# MATANUSKA-SUSITNA BOROUGH PLATTING BOARD AGENDA

**OCTOBER 1, 2020  
REGULAR MEETING  
1:00 P.M.**

**B. ANN Z. CANADAY:** The request is to divide Lots 1 & 2, ASDIP, Plat 2017-135, into 5 lots to be known as **ASDIP SQUARED**, containing 30.6 acres +/- . The property is located between E. Valley Side Circle and E. Phainopepla Circle (Tax ID 7705000L001 & 7705000L002); within the NE ¼ Section 14, Township 17 North, Range 01 West, Seward Meridian, Alaska. In the City of Wasilla and in Assembly District #4 Ted Leonard

**C. DON SHOWERS:** The request is to create seven lots from Lot 4, Block 2, Wasilla Creek Estates, Plat No. 86-17, to be known as **WASILLA CREEK ESTATES #2**, containing 10.431 acres +/- . The property is located northwest of E. Jensen Road, north of N. Bains Jordan Drive and east of Wasilla Creek (Tax ID # 53177B02L004); within the SW ¼ Section 12, Township 18 North, Range 01 East, Seward Meridian, Alaska. In Community Council: Fishhook and in Assembly District #1 Tim Hale.

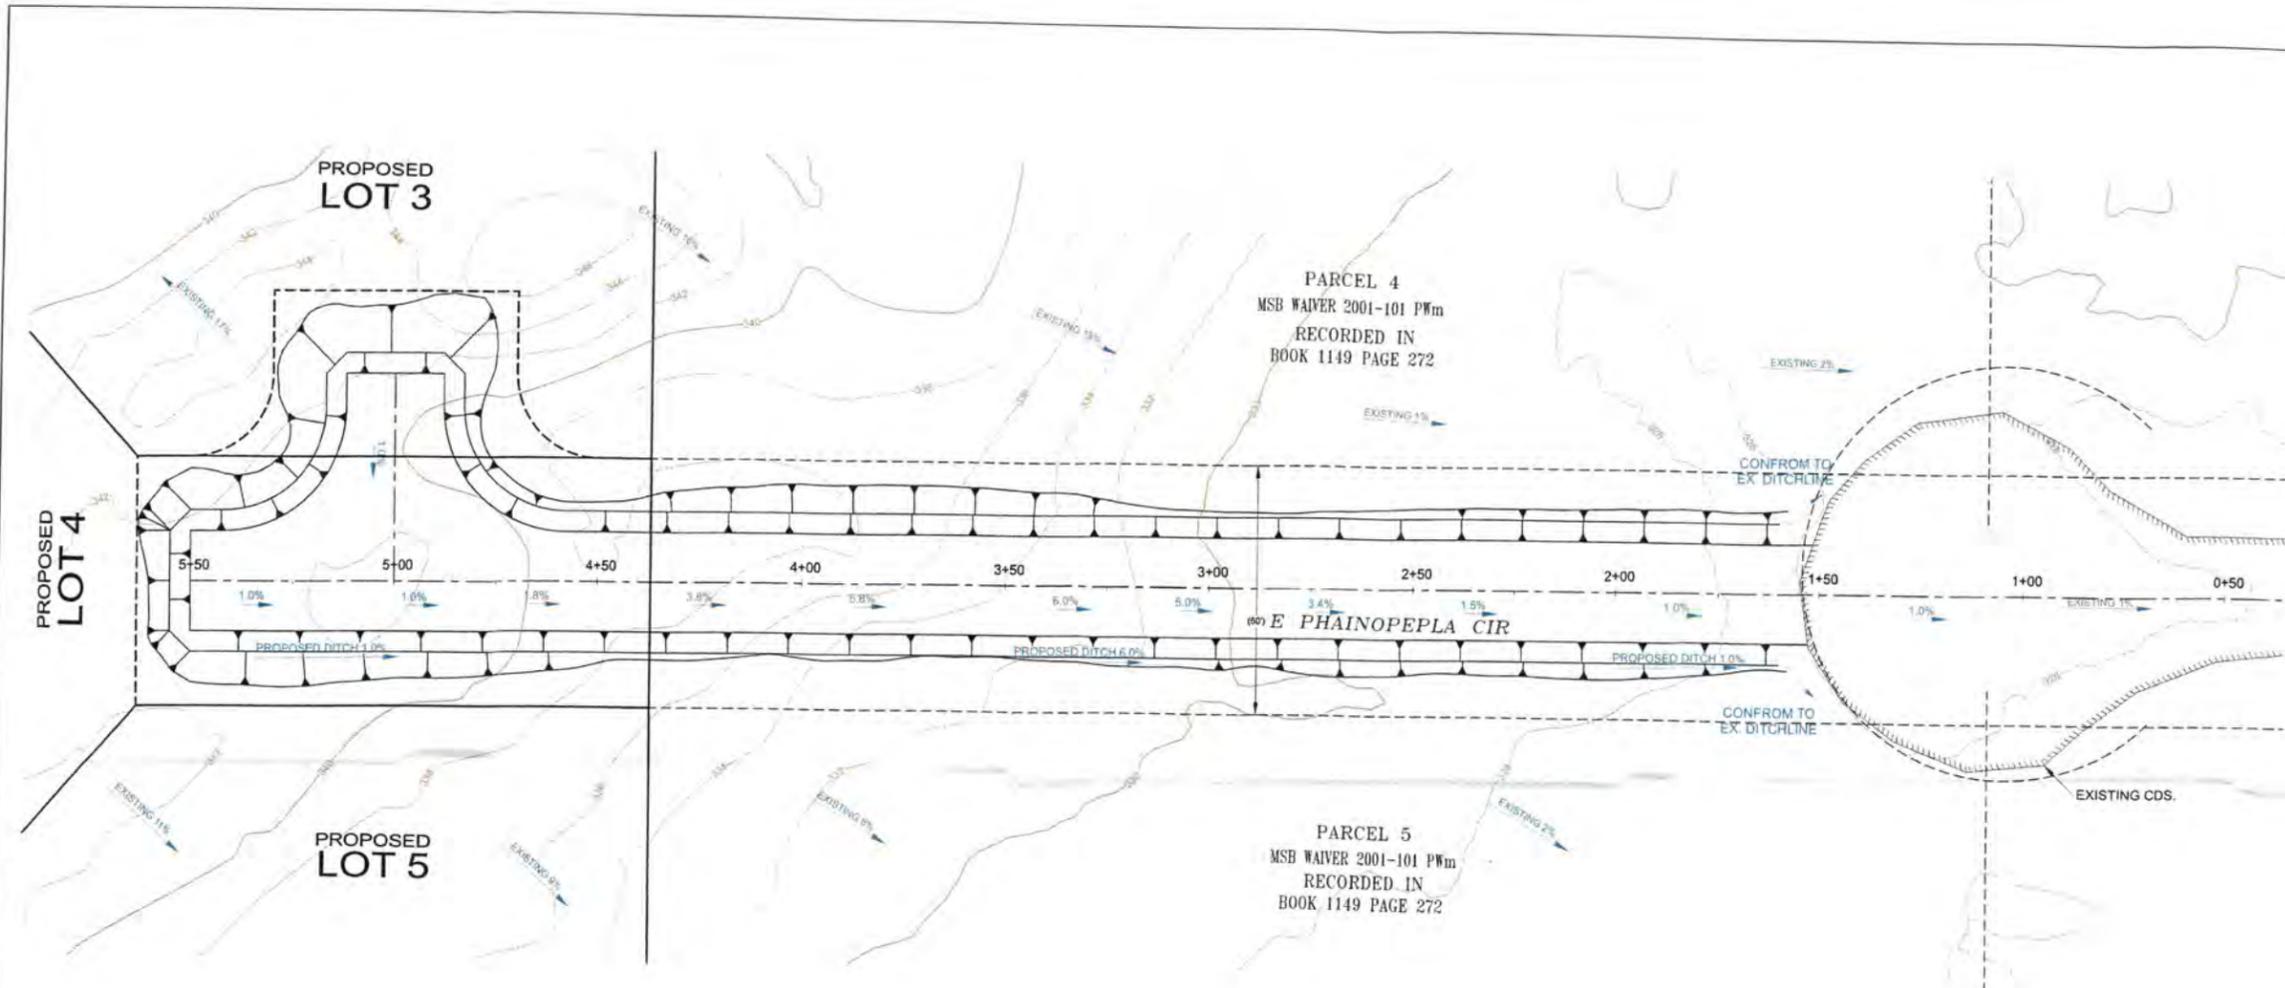
3. Construct the extension of E. Phainopepla Circle including the t-turnaround to City of Wasilla road standards. Provide verification from an RLS that the constructed roadways are located within the proposed right-of-way per MSB 43.20.140 and obtain City of Wasilla Public Works Engineer signoff.

| <p><b>PRELIM. PLAT REVIEW</b><br/>8/5/2020</p>   | <p>MAT-SU BOROUGH<br/>PUBLIC WORKS DEPARTMENT</p> <p><b>WASILLA CREEK ESTATES II<br/>PRELIMINARY CONSTRUCTION PLANS</b></p> |

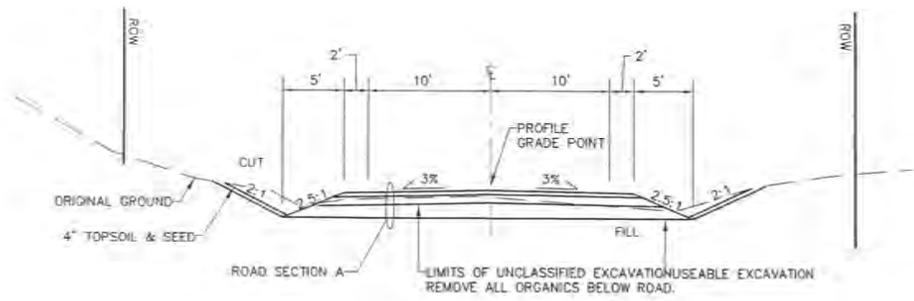
Show where useable area will be created. Construct cul-de-sac to minimum residential standards.

- b. Provide DPW acceptance of the roads to Platting staff.
  - c. Names of streets to be approved by Platting Assistant.
5. Engineer to provide a map that shows where useable area was created, in the vicinity of Testholes #4 & #5.
